OFFICE OF COMAL COUNTY ENGINEER

License to Operate On-Site Sewage Treatment and Disposal Facility

108767

2206 BRIDAL VEIL

DRAWING NO.:6887R1

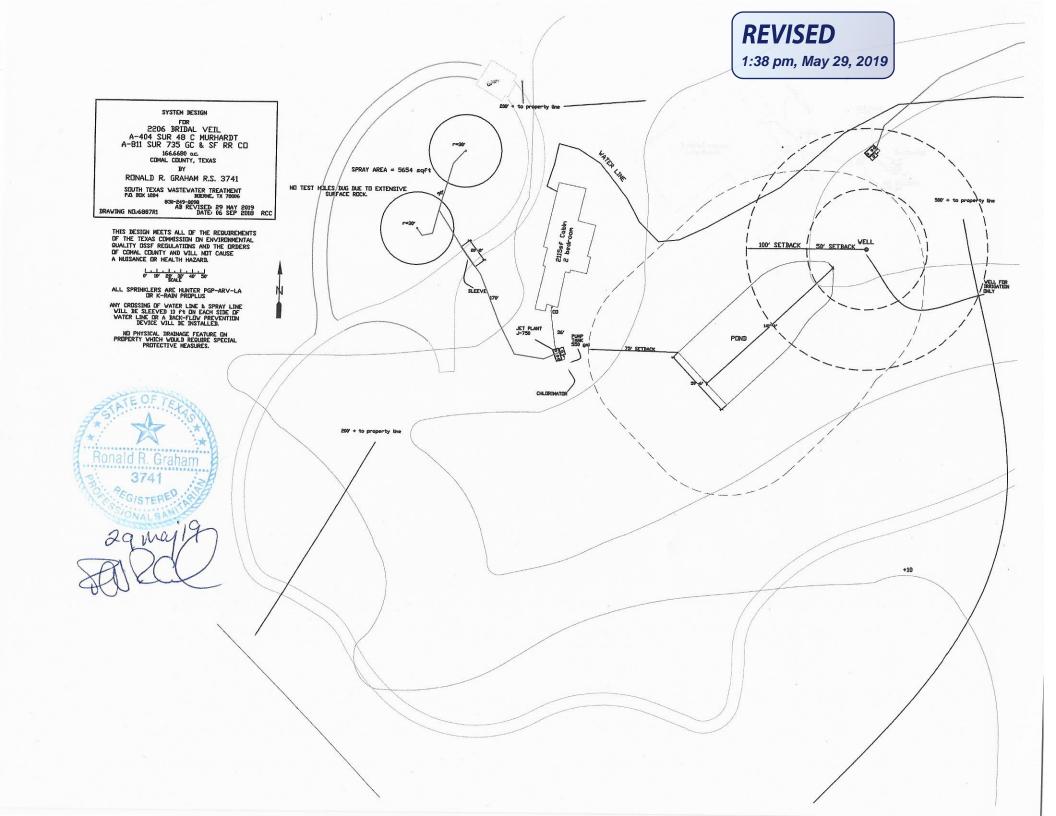
This page must also be revised to match with the latest revision.

DRAWING ND:6887R0

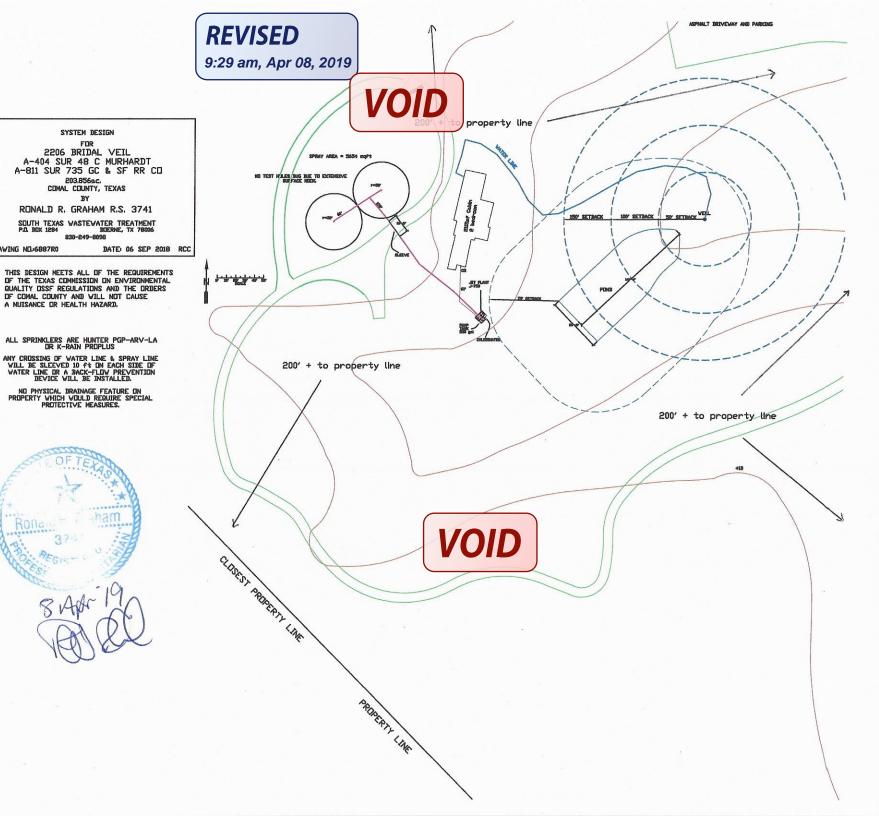
- 3. Show system and structure in relation to all property boundaries.
- 4. Show all improvements and their associated permits.
- 5. Identify what the additional sleeve indicated in yellow on the design if for.
- 6. Will the cabin be for single family use of 30 days or more?
- 7. Complete the description of the type of construction on the permit application.
- 8. Please verify if Ray Stadler is the owner of record for Shared Ownership Activity Resorts, LLC.
- 9. Revise as needed and resubmit.

- 3. Show system and structure in relation to all property boundaries. We are only submitting a permit for one structure that is being built on the acreage. I have attached a survey drawing from the builder to show relation structures in relation to property boundary.
